FIRE SAFETY INSPECTION REPORT

South East Textiles (Pvt.) Ltd (Extension)

Date: 05 March 2023

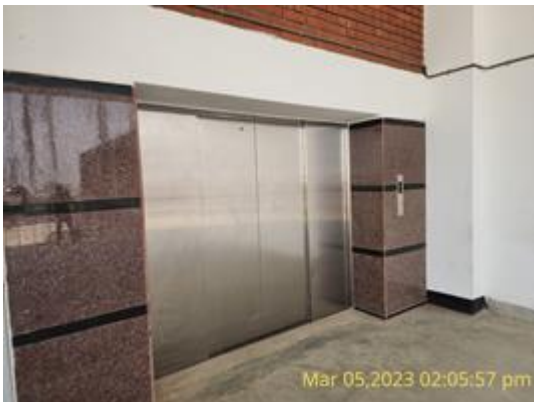
F-2	Fire Protection	The firefighting system (standpipe system) installation requires detailed review to conform compliance with NFPA 14.	Submit as built drawing, testing records, equipment certification and all relevant documents to the RSC for review, approval and acceptance test.	Within 2 months
